1994 Corvette: Service Bulletin: Garage Shift Delay Engagement (New Garage Shift Package)

Subject: Garage Shift Delay Engagement (New Garage Shift Package)

Bulletin Number: 47-71-20A

REVISION: 09/12/94

ORIGINAL GARAGE SHIFT PACKAGE

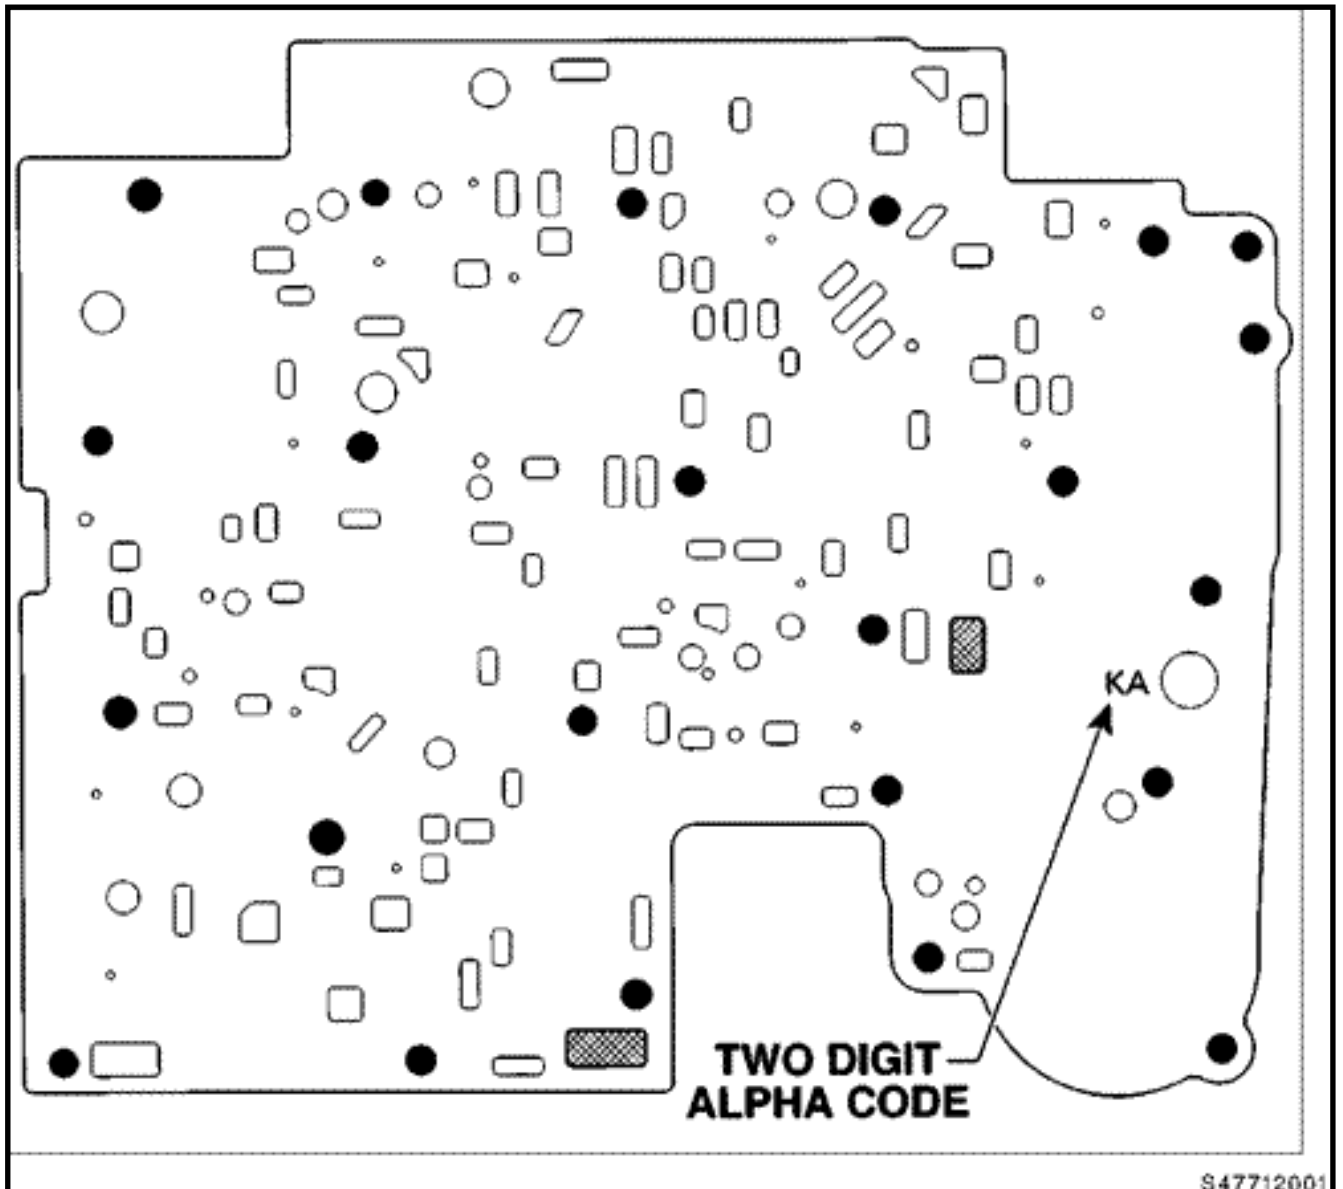
WHEN PERFORMING ANY OTHER REPAIRS ON A 1994 VEHICLE EQUIPPED WITH A HYDRA-MATIC 4L60-E TRANSMISSION BUILT BEFORE MARCH 7, 1994 (JULIAN DATE 066), THE SPACER PLATE IDENTIFICATION MUST BE

CHECKED TO SEE IF THE TRANSMISSION HAS HAD A NEW GARAGE SHIFT PACKAGE INSTALLED TO BE SURE THE TRANSMISSION IS BEING SERVICED WITH THE PROPER PARTS. SEE THE FOLLOWING CHART FOR SPACER PLATE IDENTIFICATION.

THE NEW SPACER PLATES MUST BE USED WITH THE ENHANCED GARAGE SHIFT PACKAGE AND THE ORIGINAL SPACER PLATES MUST BE USED WITH THE ORIGINAL GARAGE SHIFT PACKAGE. THE SPACER PLATES AND GARAGE SHIFT PACKAGES ARE CALIBRATION SENSITIVE; MIXING SPACER PLATES AND GARAGE SHIFT PACKAGES MAY CAUSE PREMATURE FAILURE. WHEN A GARAGE SHIFT PACKAGE IS CHANGED, THE SPACER PLATE MUST ALSO BE CHANGED.
